NIRB File No. 11RN017
NWB File No.: 2BB-MEL0914
KIA File No.: KVRW11F02 and KVCA11Q01

Re: Opportunity to address comments received regarding AEM's "All-Weather Road" project proposal

AEM Reference: Information Request # 1

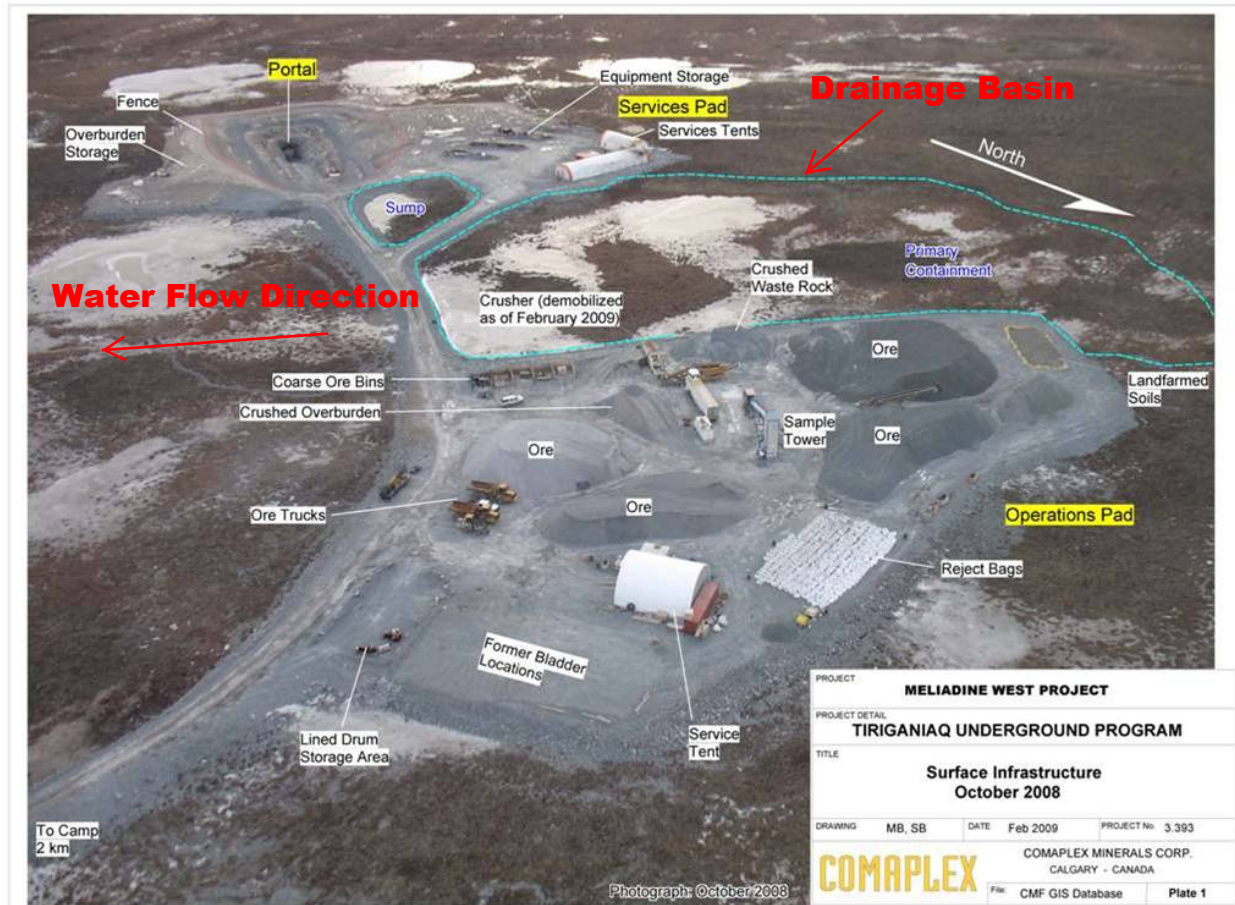
INAC identified the following deficiencies in relation to acid generation and metal leaching, and requests that NIRB solicit the missing information or required clarifications from the proponent:

- i) It is not clear that the assessment of metal leaching is adequate. It appears that the proponent dismisses leach test results obtained through static testing that indicate exceedances of "Canadian Water Quality Guidelines for the Protection of Freshwater Aquatic Life" as not necessarily reflecting what will actually happen in operation. No field tests are available at this time and it the Proponent appears to suggest that water quality monitoring at the Primary Containment Area can be used to estimate future results. The Proponent does not explain or substantiate of the adequacy of this or explain and how the use of this proxy may affect the certainty of the results. The Proposal states that the proponent will have a better understanding of the potential for metal leaching after future data collection. As a result, INAC is not certain whether the proponent believes that its current understanding of the potential for metal leaching is sufficient for the purposes of impact assessment. If the proponent believes that its current understanding is sufficient at this stage, the proponent should explain and substantiate this conclusion.*

- ii) The Primary Containment Area (PCA) is not described. INAC presumes that the proponent is referring to the containment area associated with the proponent's proposed underground exploration program, however as this is a separate NIRB process, it would be helpful if the proponent clarified what the PCA refers to, especially as it appears to be a crucial element of this section of the Proposal.*

The proponent states that "Monitoring of the PCA and various water bodies in the immediate vicinity of the PCA will continue in 2011." However the proponent does not identify these water bodies, or state the methodology by which they were or will be selected. The proponent has also not provided a monitoring plan.

Plate 1 shows the Primary Containment Area, its drainage basin and the direction of water flow. The area of the drainage basin is 14.2 hectares. The average yield is approximately 100 mm resulting in an estimated annual runoff volume of 14,400 m³ per year. Ice can be seen in Plate 1 against the operations pad and the road between the two pads. The pads are sloped to drain into the PCA. The rock type used in building the pads and the roads is a greywacke/siltstone. This material, along with other types of waste rock, underwent static (geochemical) testing by Golder Associates.

Figure 1 shows the water sampling location in the PCA and water bodies that are monitored downstream. The direction of flow from the PCA is into Lake A54 followed by Lakes A38 and A8, all of which are monitored. A parallel path from Lake A15, Lake A13, Lake A9 to Lake 8 is also sampled but receives no water from the PCA or the pads.
